Questions and Answers from PAC-37 Day 2

NSTX-U PAC-37

January 27, 2016

Personnel allocation (head-count) sorted by research area of emphasis / Science Group

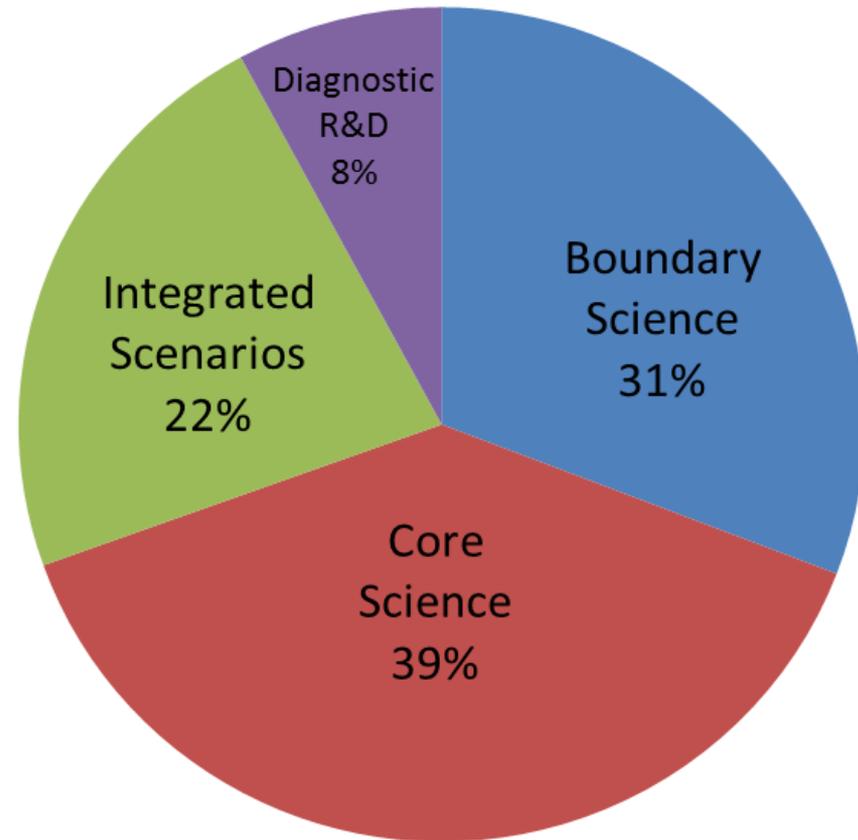
1. What is the personnel allocation (FTE or headcount) by research group or topic?
2. What is the QC/QA and pre-testing plan for the solid high-Z tile row to be installed for the FY17 run? What will be done to verify both the materials and design in advance of installation of all the tiles?

- ~290 NSTX-U scientists in total
- Assign single label to each scientist
 - Boundary
 - Core
 - Scenarios
 - Diagnostic R&D

Post-mortem analysis will verify performance after first run-year

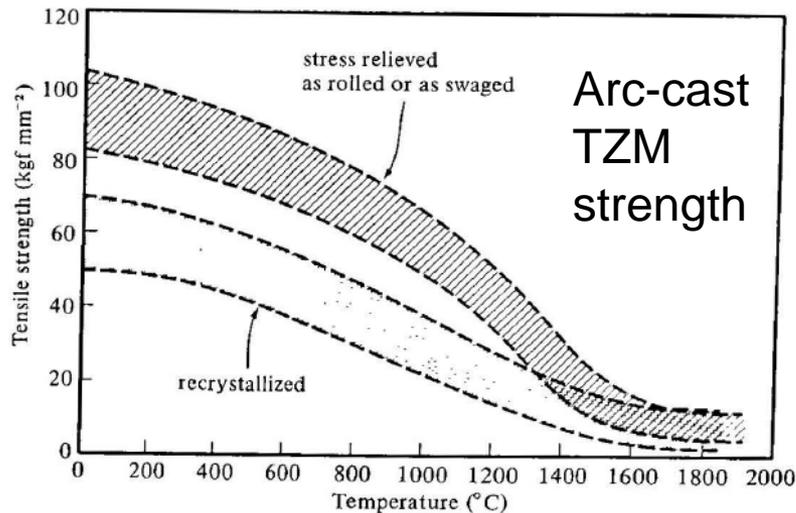
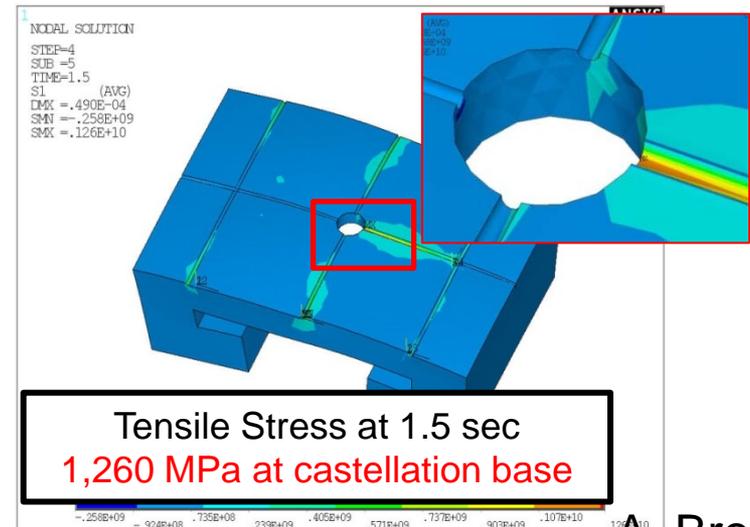
What is the QC/QA and pre-testing plan for the solid high-Z tile row to be installed? What will be done to verify both material and design? (Jaworski/Tresemer)

- Most likely point of failure determined through extensive thermo-mechanical analysis
 - Castellations base results in stress concentration
 - Opening force along T-bar spine
 - Grain orientation specified that this is a longitudinal stress (maximum strength)
- Extra tiles procured so that a subset can be destructively examined post-run
- These experimental tiles are an engineering (and procurement) test for the cryo-pump divertor PFCs
